Product hierarchy no. *				Part no.	SBU	Type / Description	Customer part no.
SBU	PG	PUG	Type				
02	005	016	0000001104	See list below	Power Entry Modul 10A	6202

Change country of origin

Product Change Notification					6202 change country of origin		
owner	creation date	release date	released by	change order no	rev	page	D10-046-587
sariogar	22.06.2020	23.06.2020	muehlema	2020156	A	1 of 1

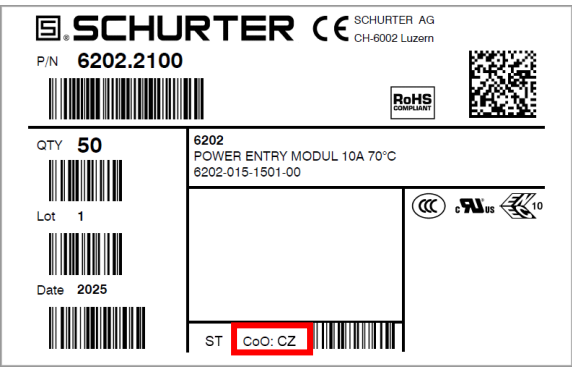
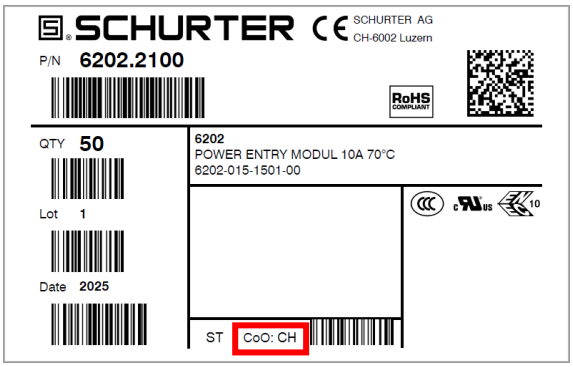
Change country of origin from Czechia (CZ) to Switzerland (CH)
